**Re: Semet Residue Ponds Groundwater Remedial Alternative 2016 Annual Report
Order on Consent: Index# D7-0004-01-09**

SEMET RESIDUE PONDS TRIBUTARY 5A 2016 ANNUAL REPORT RESPONSE TO COMMENTS

This document is being provided in response to the New York State Department of Environmental Conservation's comments received via email on **June 09, 2017**, and was developed by OBG on behalf of Honeywell International, Inc. For ease of review, NYSDEC comments are listed first in *italics* followed by the response in **bold** text.

Honeywell Tributary 5A 2016 Annual Report

Figure 4

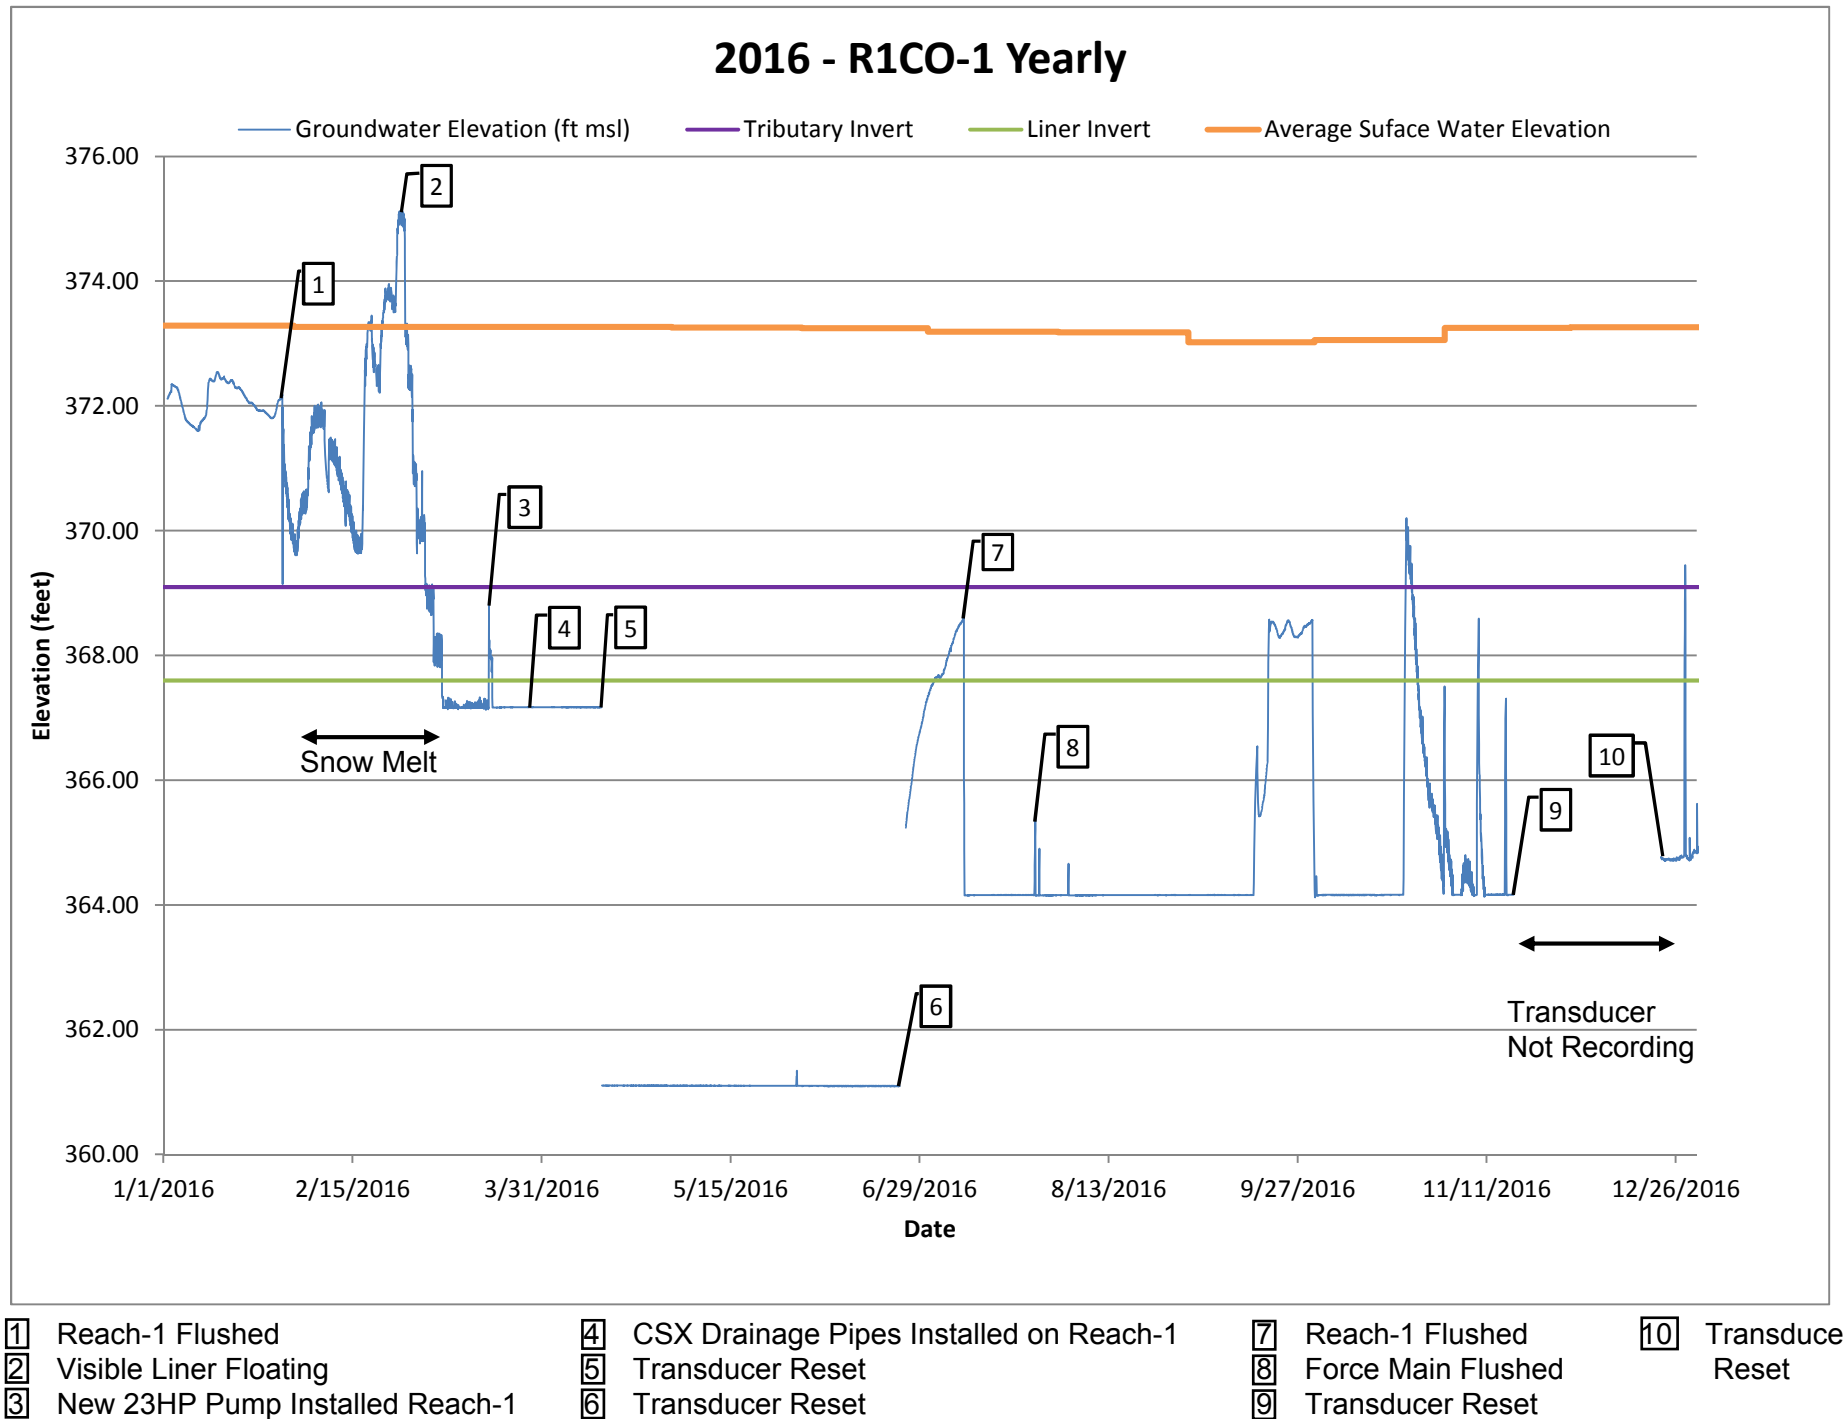
5. *Page 14, Paragraph 2, Sentence 2, Section 3.5. In order to be consistent with Figure 4, the reference here to SP-SEEP-15 be revised to SP-SEEP-15A.*

Reference has been revised to "SP-SEEP-15A".
